Interactive comment on “Stochastic Wake Modeling Based on POD Analysis” by D. Bastine et al.

D. Bastine et al.

Received and published: 13 February 2017

Fig. 1. Convergence of the eigenvalues: Eigenvalues estimated using temporal averaging over different times T . Here, the time between two snapshots used is 0.6 s.

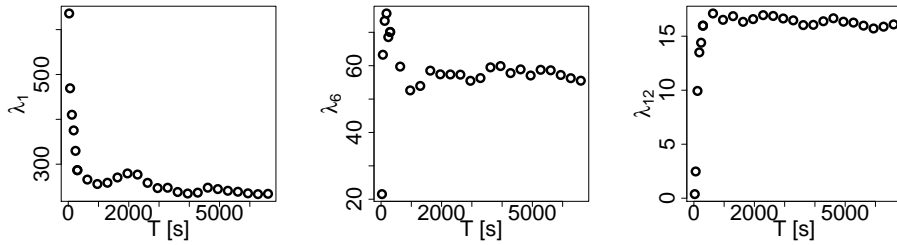
16. Fig. 5a: Can you show the convergence of the POD eigenvalues and POD modes of interest for different numbers of snapshots and different sampling time?

17. Fig. 6. POD modes typically capture flow dynamics as couple of two POD modes with about same energy content (POD eigenvalues), spectral content, but they are orthogonal. Your first POD mode is clearly isolated and decoupled from the other modes. Therefore, it should not be associated with flow dynamics. In contrast, this might be a sign of not-achieved convergence of the POD analysis. If you try to reduce

the number of snapshots, then energy of this mode should increase. Can you please verify my speculation?

The eigenvalues and POD modes in our work have actually converged relatively well for most values and modes of interest. For example, the first eigenvalue has reached approximate convergence already after around 1000 s of data (see Fig. 1 left of this reply), when using a snapshot every $\Delta t = 0.6$ s. Moreover, the corresponding first POD mode stays almost the same after around 1000 s as well (Fig. 2 of this reply). Similar results can be found for other eigenvalues and modes (Fig. 1, Fig. 2, Fig. 3 of this reply). For high mode numbers $n > 15$, the convergence of the modes sometimes gets less good, which is an additional reason for using only a few POD modes and try to capture small-scale structures in a different way, as discussed in other comments.
